ATTACHMENT B
License
and
Technical Specification Changes

Lic. Page 3

T.S. Pages 6
7
8
9
11
12
13
14
15
18
20
21
27
54
127
127A
127A-1
205A
205B
205C

Figure 2.1.1

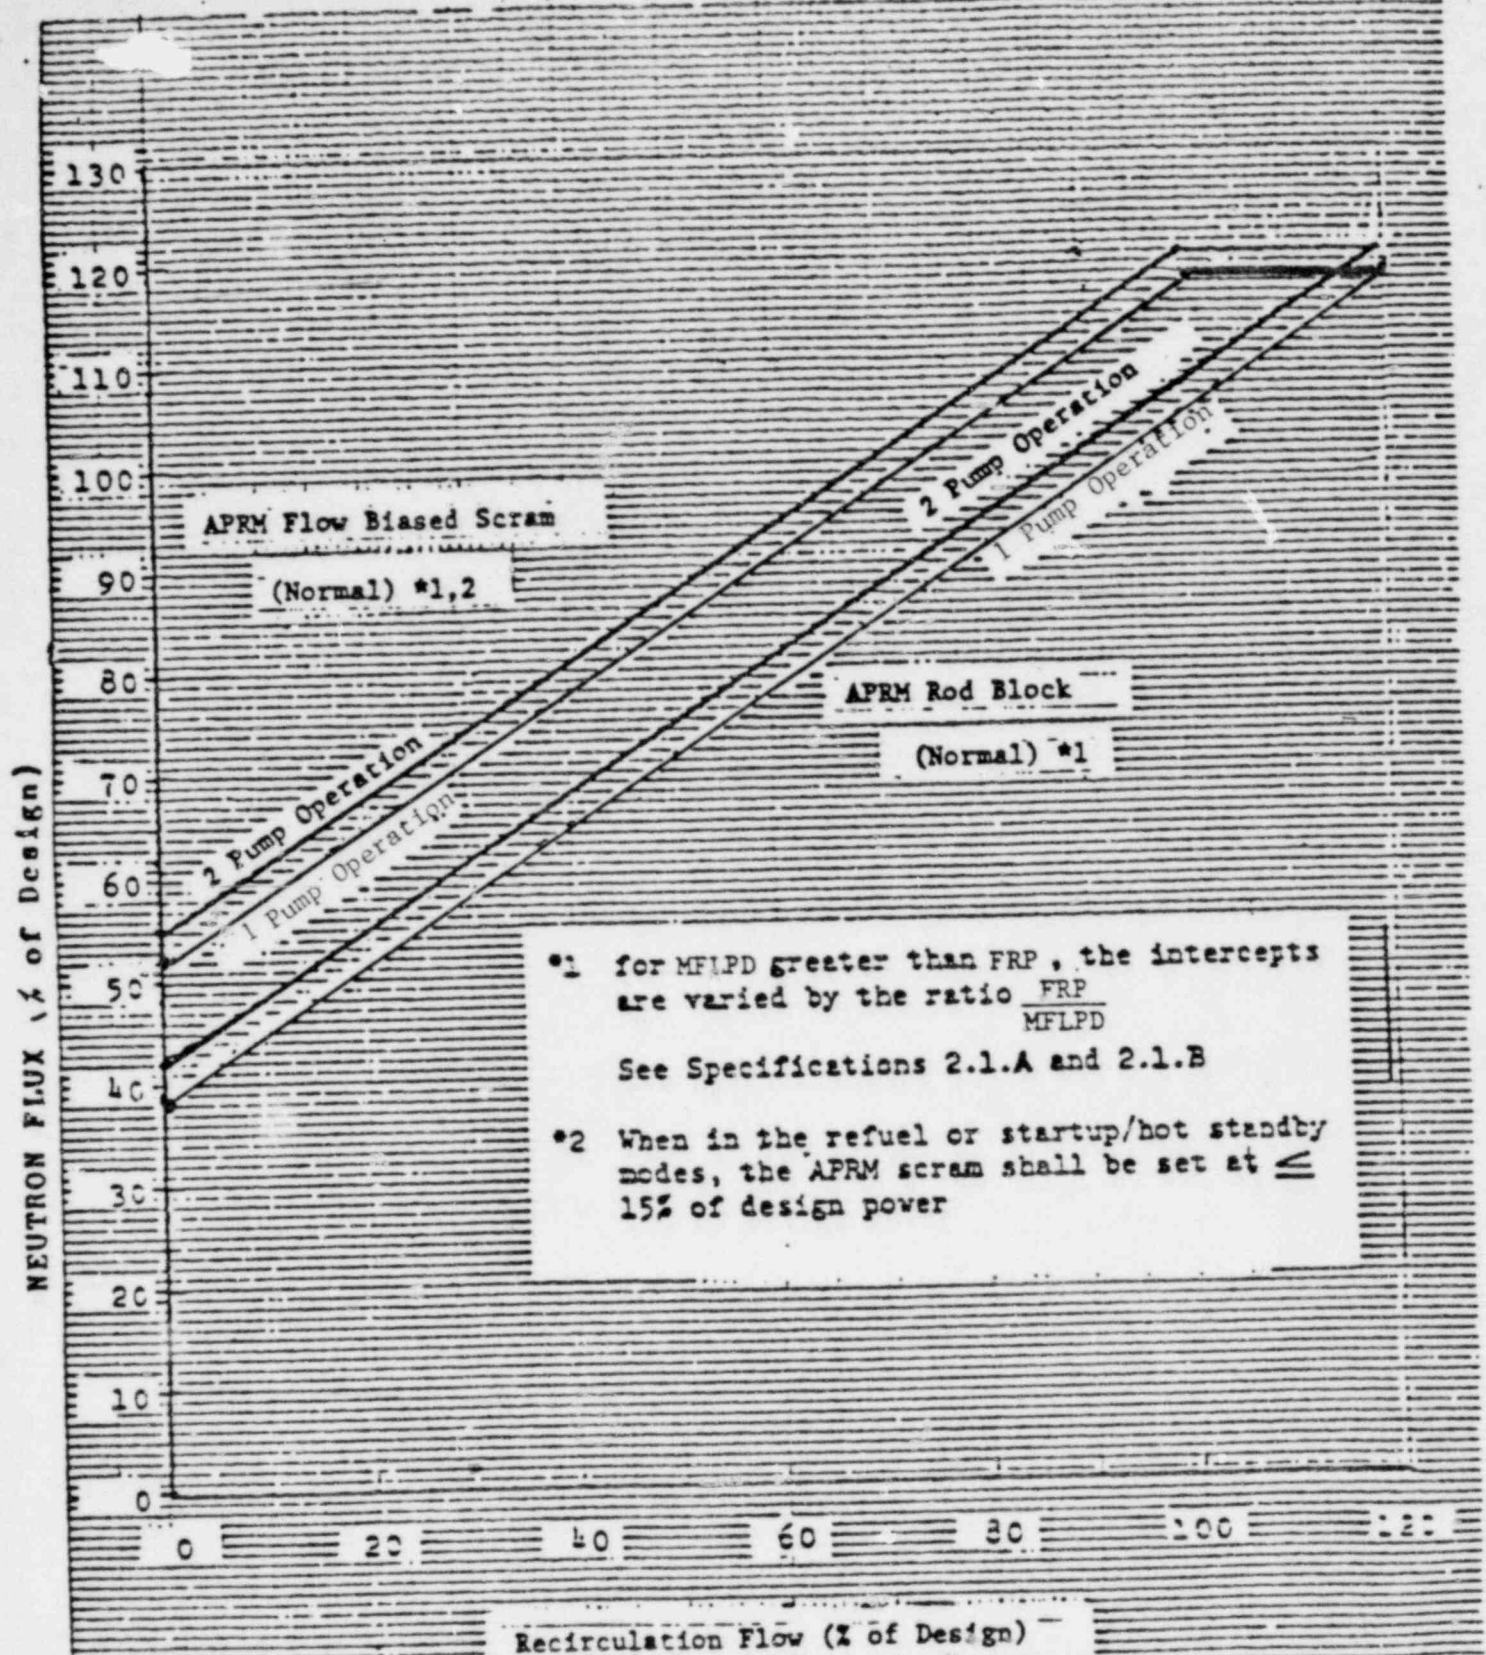
The flow biased scram plotted on Figure 2.1.1 is based on recirculation loop flow. Figure 2.1.3, which shows the flow biased scram as a function of core flow, has also been included.

APRM FLOW BIAS SCRAM VERSUS REACTOR CORE FLOW
FIG. 2.1.3

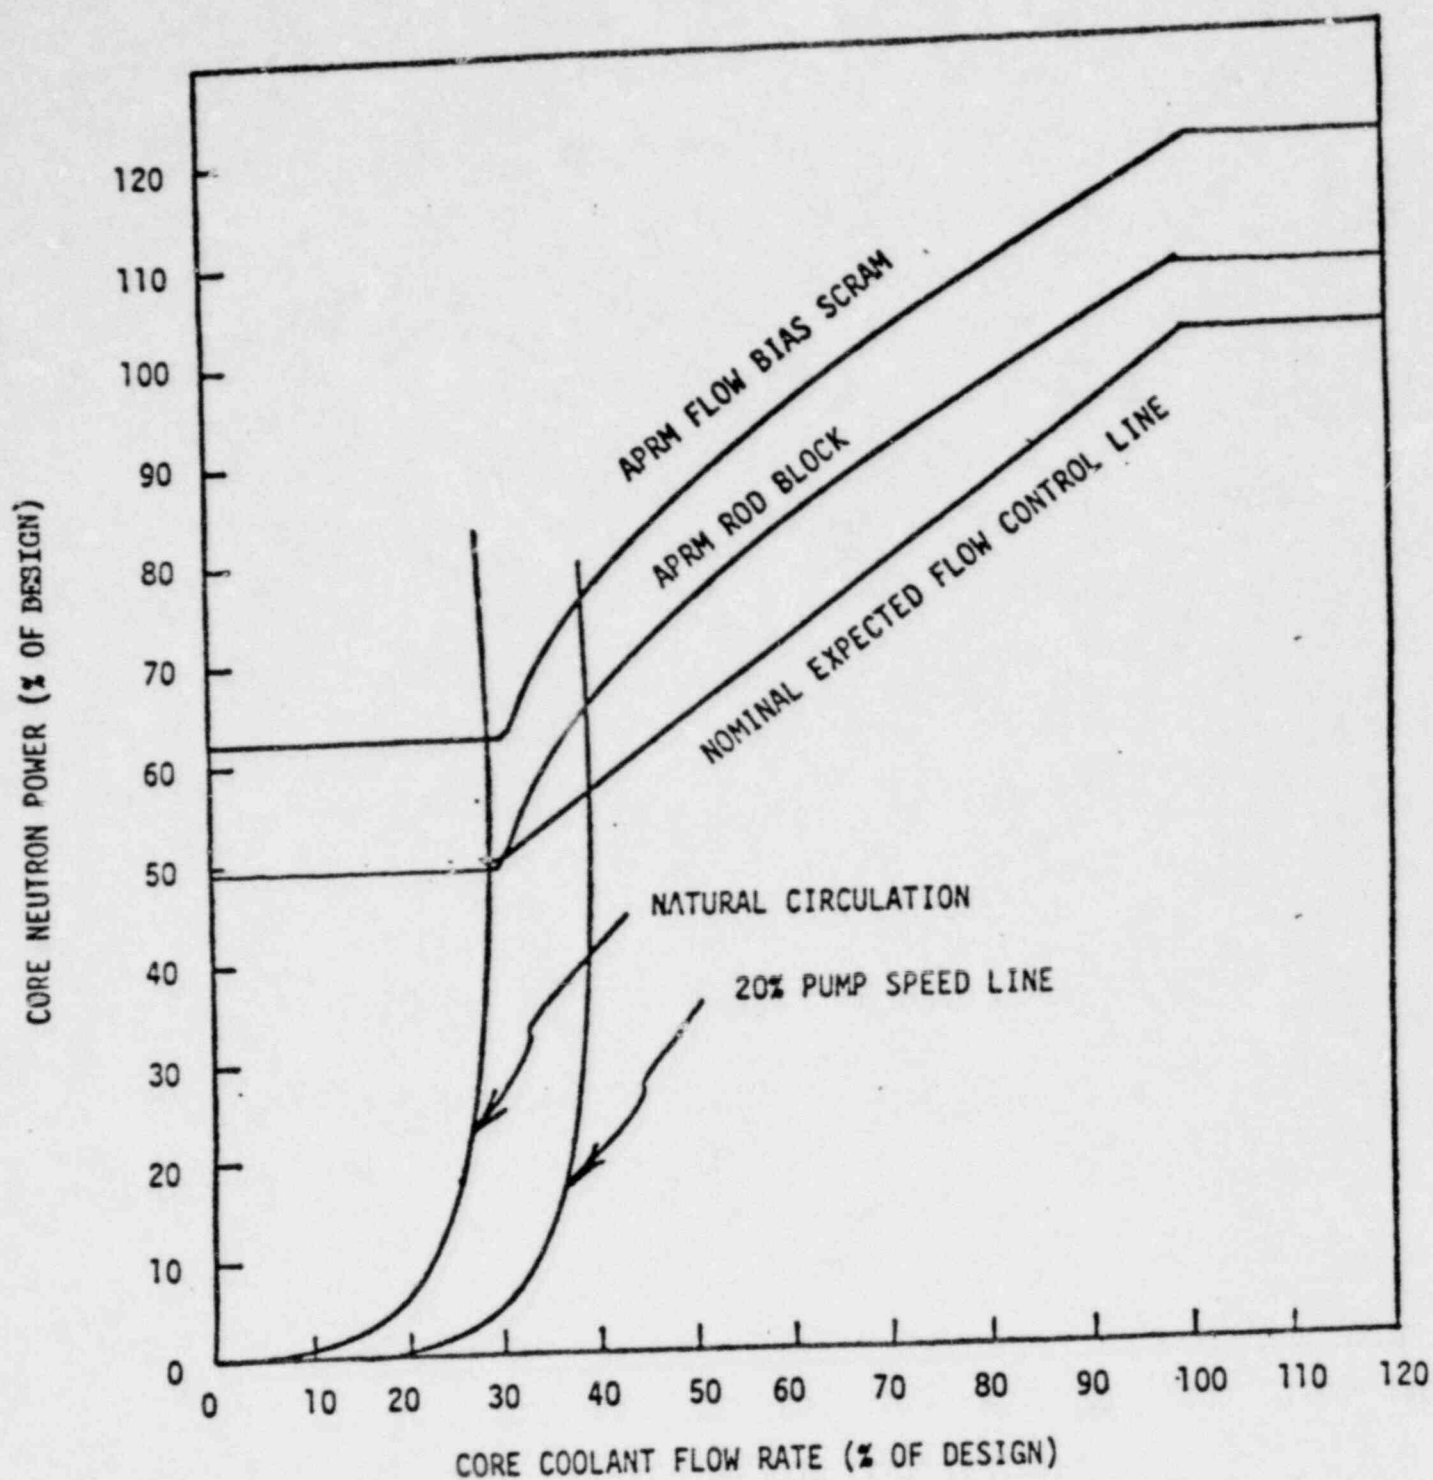
Figure 2.1.3 above represents the APRM two loop flow bias scram with neutron flux plotted against core coolant flow rate instead of recirculation loop flow as shown in Figure 2.1.1.
